Technical Specification Group, Terminals
Meeting #2, Fort Lauderdale, 2-4 March 1999

TSGR#2(99)120

Title: **Liaison statement from CEPT ERC TG1 to 3GPP groups**

Liaison Statement from CEPT ERC TG1 to 3GPP TSG RAN WG4

Figure 1 – TG1 Assumed Base and Mobile Transmit Masks

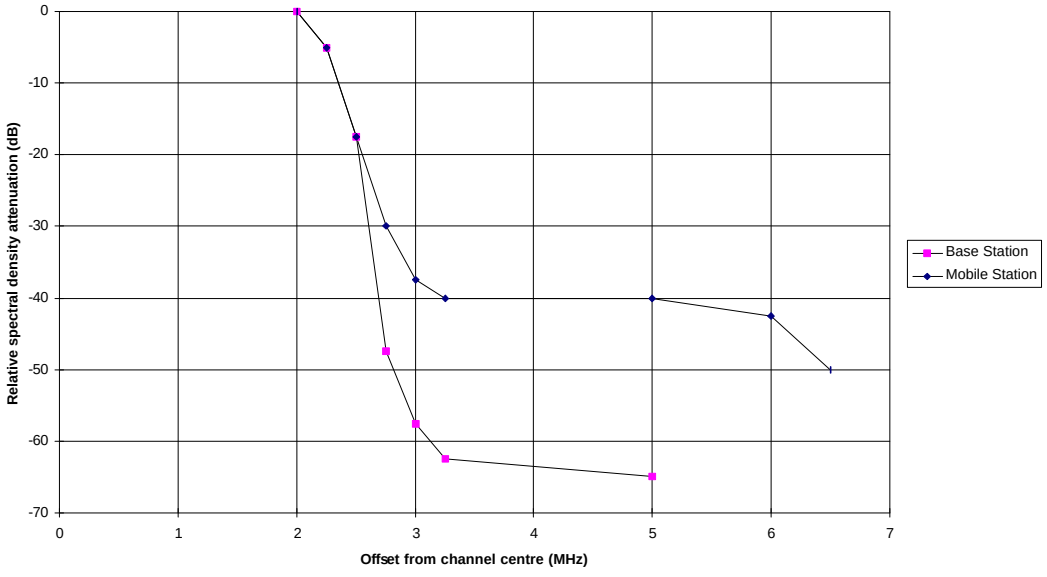
It should be noted from the masks above that the assumed mobile ACP is 40 dB and the base ACP more than 60 dB at a 5 MHz carrier spacing.

Thus in the case of mobile station ACP, the current assumption within TG1 lies at the extreme limit of the RAN WG4 range. In the case of base station ACP the current assumption within TG1 lies outside the RAN WG4 range. Concerns have been expressed within TG1 that the current assumptions are too stringent relative to what is practical and what 3GPP is likely to conclude. TSG RAN WG4 is therefore requested to urgently provide TG1 with the latest information regarding UTRA unwanted emissions transmit mask. TG1 believes it would be of great value to receive a mask rather than ACP values.
